Hatfield Aerodrome

Addendum to Environmental Statement 2024

Brett Aggregates Limited

Revision: 03 FINAL

Figure 2-1: Sequence of Phases (top submitted, bottom alternative option)

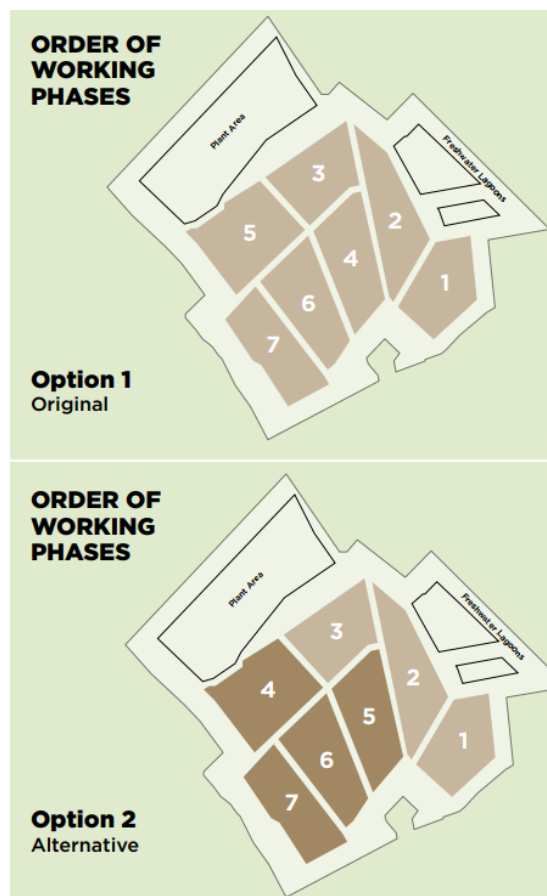
2.7 Having reviewed the order of the phases, the Appellant considers that the sequence of the phases could be amended after Phase C. On completion of Phase C, the workings would continue in a westerly direction into Phase E. On completion of Phase E, the workings would commence in Phase D and advance southwards (as per the submitted scheme). On completion of Phase D the workings would progress into Phase F and advance northwards towards the northern limit of the Phase. The workings would then progress into Phase G and work in a general southerly direction. This is referred to as "Option 2".

- 2.8 This change to the phasing sequence is illustrated in Figure 2-1 below with the top image shows the submitted order and the bottom image shows the alternative order.

- 2.9 There are no changes to the rate of production, method of extraction or plant (fixed and mobile) to be used. The change solely relates to the chronological order of working areas of the site.

**OVERALL PHASING /
GENERAL LAYOUT**

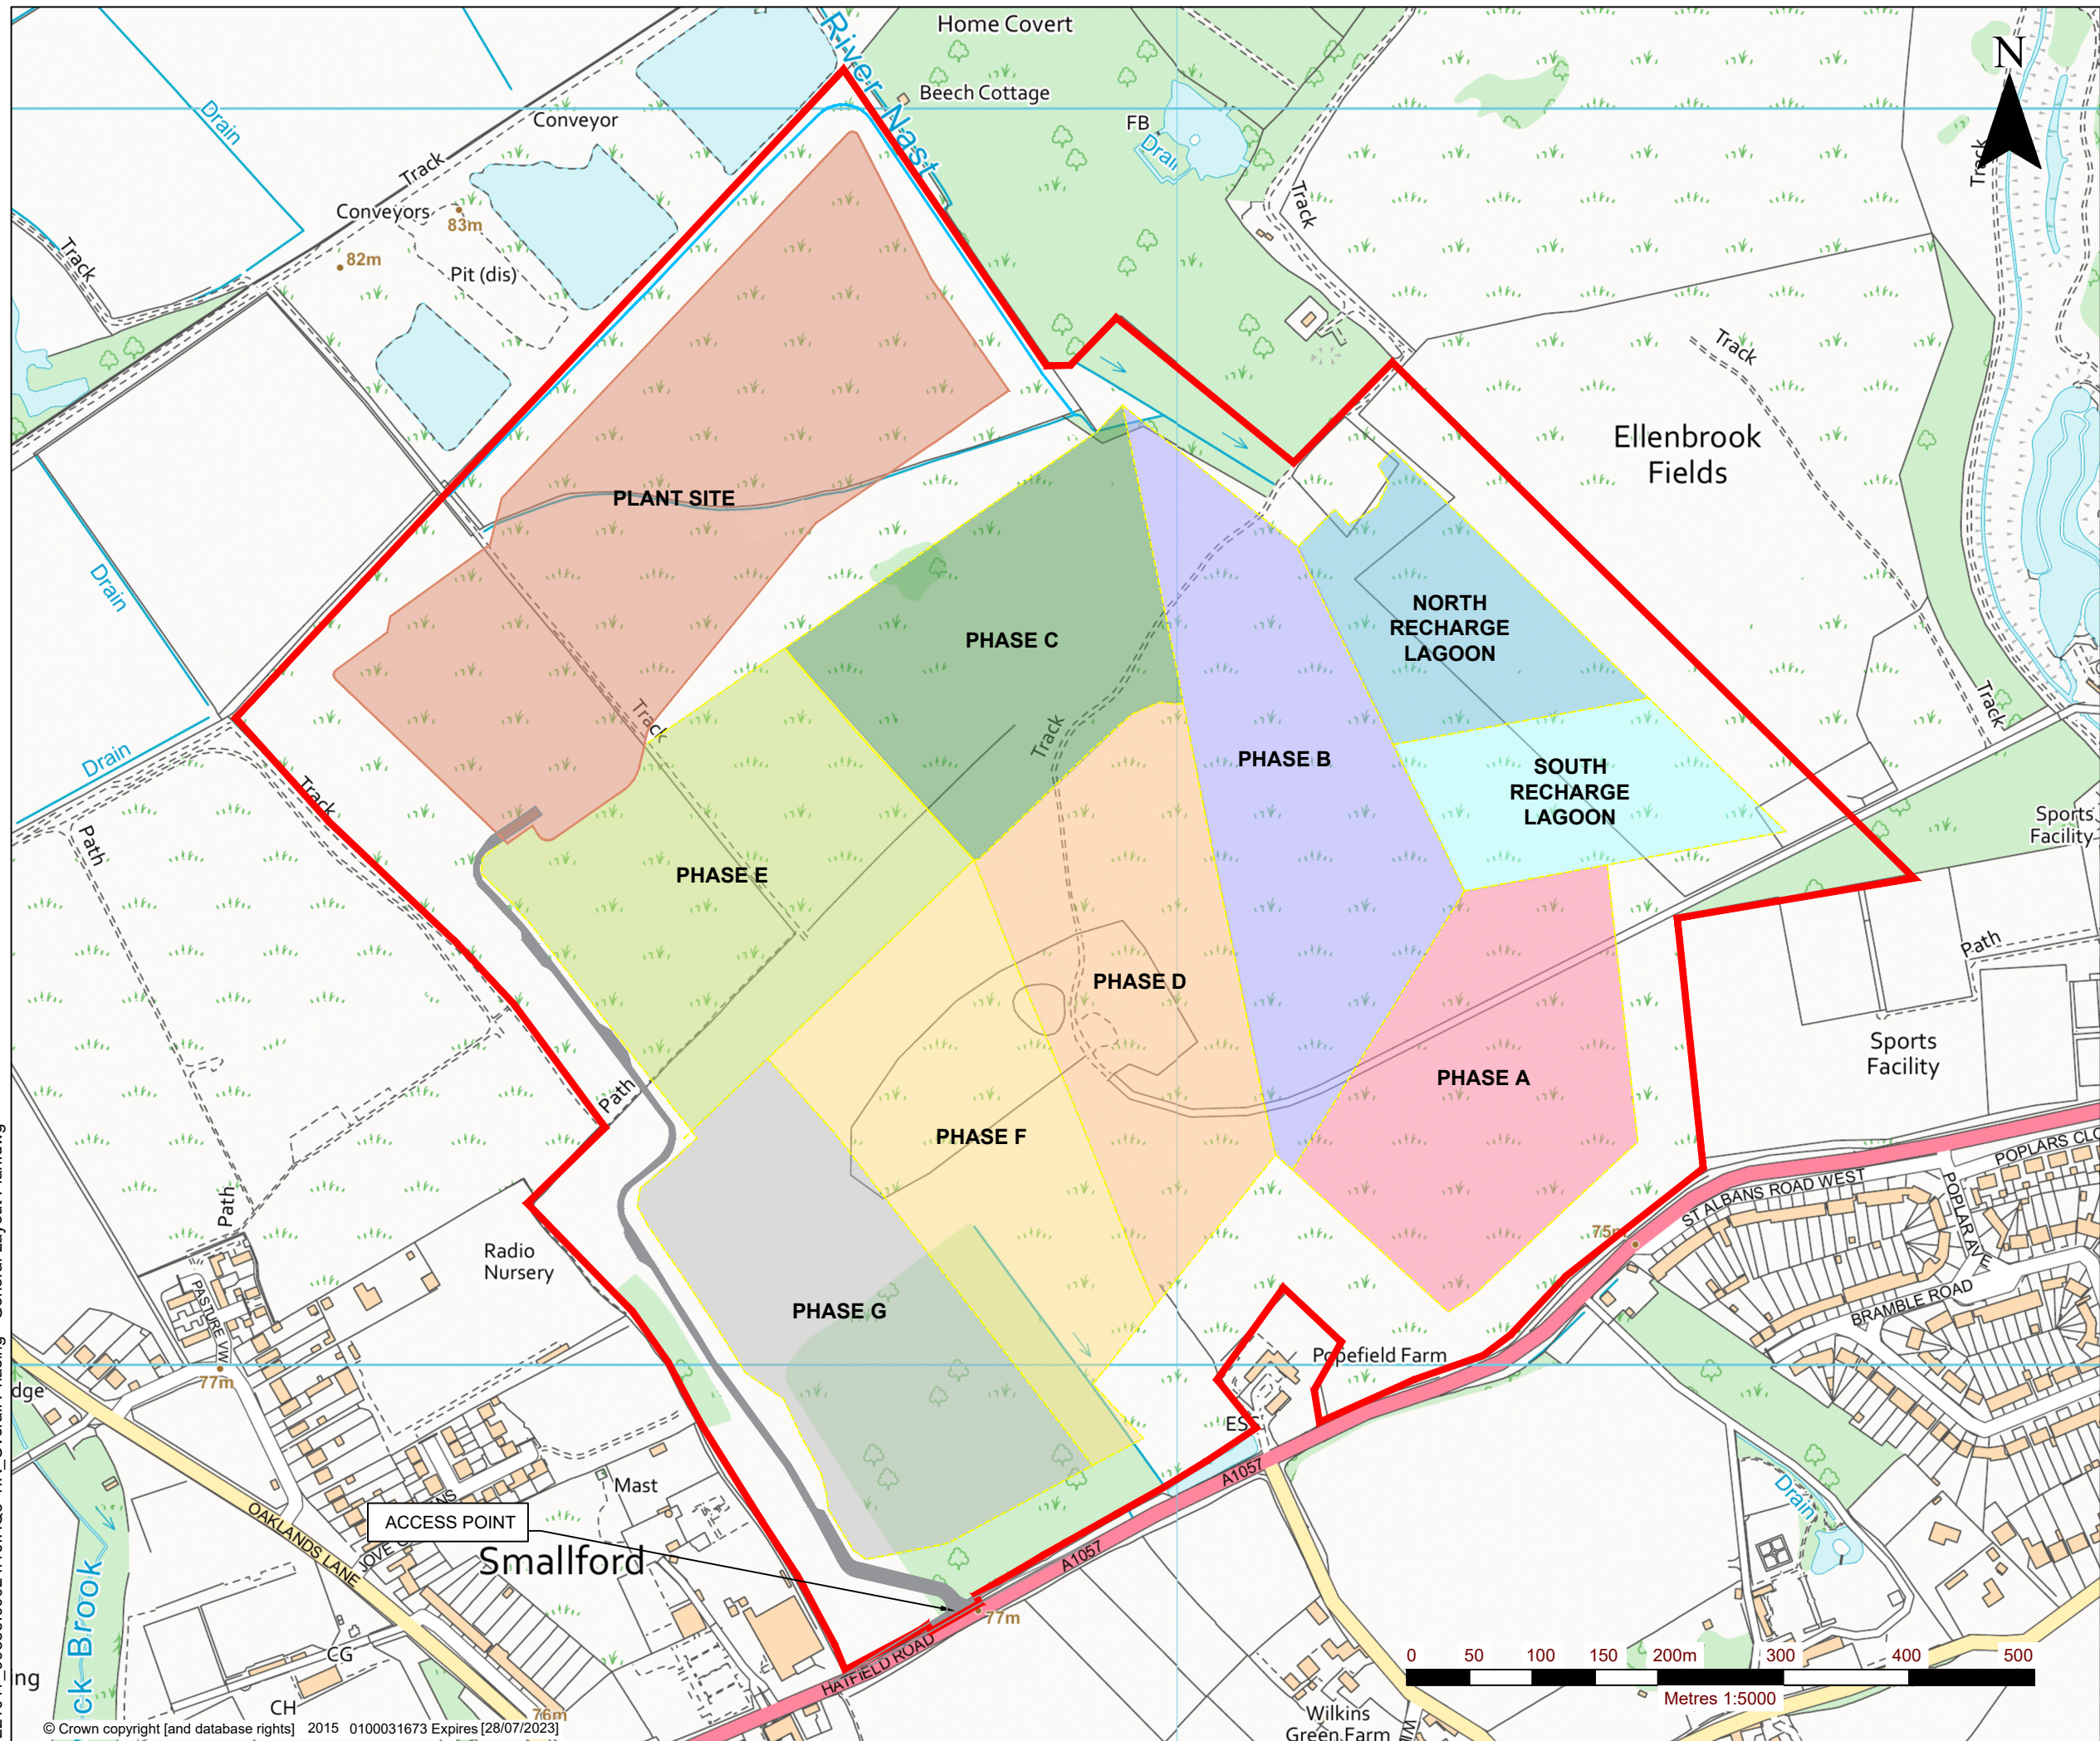
2.6 The submitted working scheme showed the mineral deposit being worked over a series of seven phases (shown as A to G on Drawing HQ 3/1R). The general direction of working would start in phase A, located in the south-eastern corner, advance northwards through Phase B, turn westwards into Phase C and then south through Phase D. On completion of Phase D, the workings would move to Phase E, located to the south of the plant site and again advance southwards through Phase E and F before working the final phase (Phase G). This is referred to as "Option 1".
